**WHITE LAKE TOWNSHIP  
ZONING BOARD OF APPEALS  
REGULAR VIRTURAL MEETING  
May 27, 2021 at 7:00 PM**

**TO:** Zoning Board of Appeals  
**FROM:** Justin Quagliata, Staff Planner  
**DATE:** June 24, 2021

**Preliminary Site Plan**  
 "Pontiac Lake Overlook"  
 PART OF THE SW 1/4 OF SECTION 13, T.3N., R.8E.,  
 WHITE LAKE TOWNSHIP, OAKLAND COUNTY, MICHIGAN

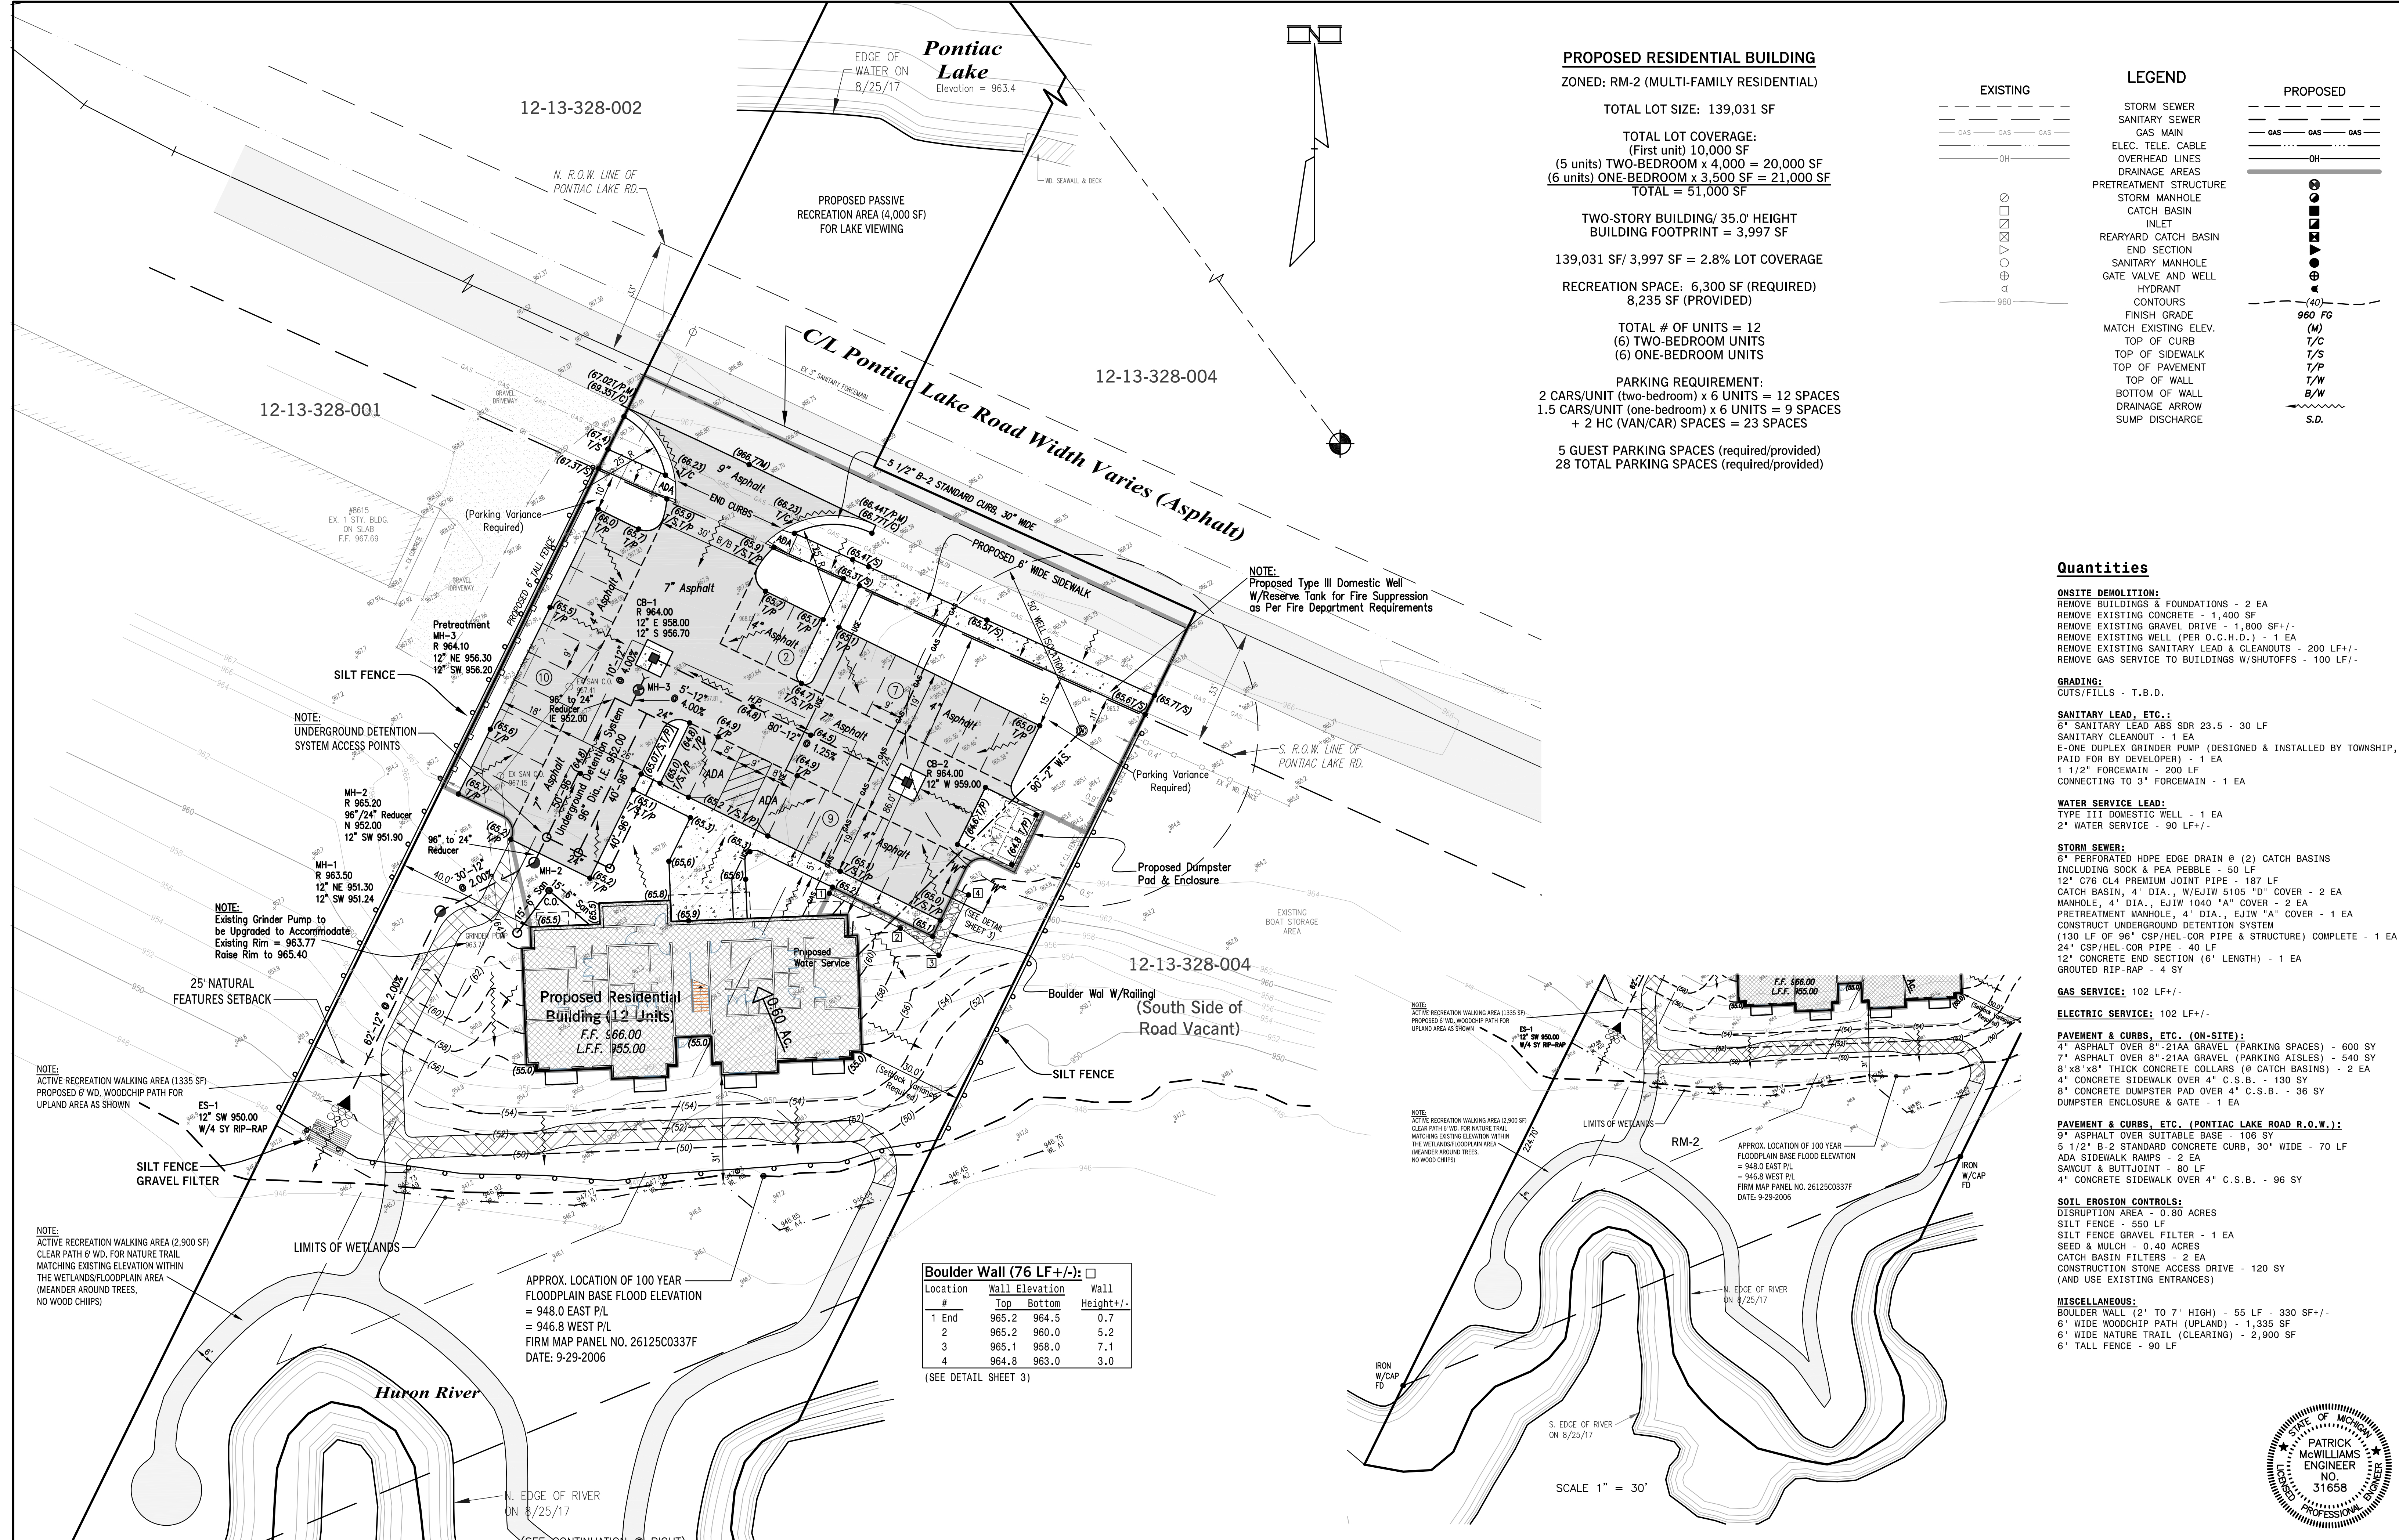
The minimum side yard setback in the RM-2 zoning district is 70 feet on one side, 100 feet total of two sides. The proposed side yard west of the building is 40 feet; therefore, a 30-foot variance is being requested. To the east of the building the proposed side yard is 30 feet. For reference, the property to the east is zoned R1-C (Single Family Residential) and the property to the west is zoned RM-2. On the previous plan, the east side yard was 27.7-feet and the west side yard was 30-feet. A 42.3-foot variance was previously requested for the east side yard. Overall, the side yard variance request was reduced by 12.3-feet, from 42.3-feet to 30-feet.

The parking lot is located five feet from the west side lot line and 13.5 feet from the east side lot line, with no screening as previously described proposed; therefore, the applicant is requesting a 65-foot variance for the west side parking setback and a 16.5-foot variance for the east side parking setback. On the previous plan, the east and west sides of the parking lot were both located five feet from the side lot lines, and the requested variances were 25-feet on the west side 65-feet on the east side.

Article 5, Section 19.N.i.C states trash enclosures are not permitted within a required front yard setback, nor closer to the front lot line than the principal building. The proposed dumpster enclosure is located closer to Pontiac Lake Road than the apartment building, and does not meet the front yard setback. A 38-foot variance is required to encroach into the front yard, and a 2.5-foot variance is required to encroach into the front yard setback. Since the previous plan, the projection in front of the building was reduced eight feet (from 46 feet).

The zoning ordinance requires curbing for the construction of a parking area in order to control stormwater flow from the parking area and in order to protect landscape areas, such as landscape islands and other plantings. Stormwater is proposed to be detained by installation of underground detention with a pre-treatment structure. A permit is required from the Michigan Department of Environment, Great Lakes, and Energy (EGLE) for discharge into the Huron River/wetland. Article 5, Section 19.B.v states all required landscape areas and screen walls which abut vehicular drives, parking or other use areas shall be separated from the vehicular use area with a six (6) inch minimum curb of concrete construction. Additionally, Article 5, Section 11.Q.xviii states concrete curbing shall be provided at the end of all parking areas and stalls. The submitted site plan does not show the required curbing. Therefore, the applicant is requesting a variance to waive the installation of curbing.

- The Applicant shall obtain all necessary permits from the White Lake Township Building Department.
- The Applicant shall receive preliminary site plan approval from the Township Board and final site plan approval from the Planning Commission.
- A permit from the Road Commission for Oakland County (RCOC) shall be required for all work within the Pontiac Lake Road right-of-way.
- A permit from the Michigan Department of Environment, Great Lakes, and Energy (EGLE) shall be required for stormwater discharge into the Huron River/wetland.
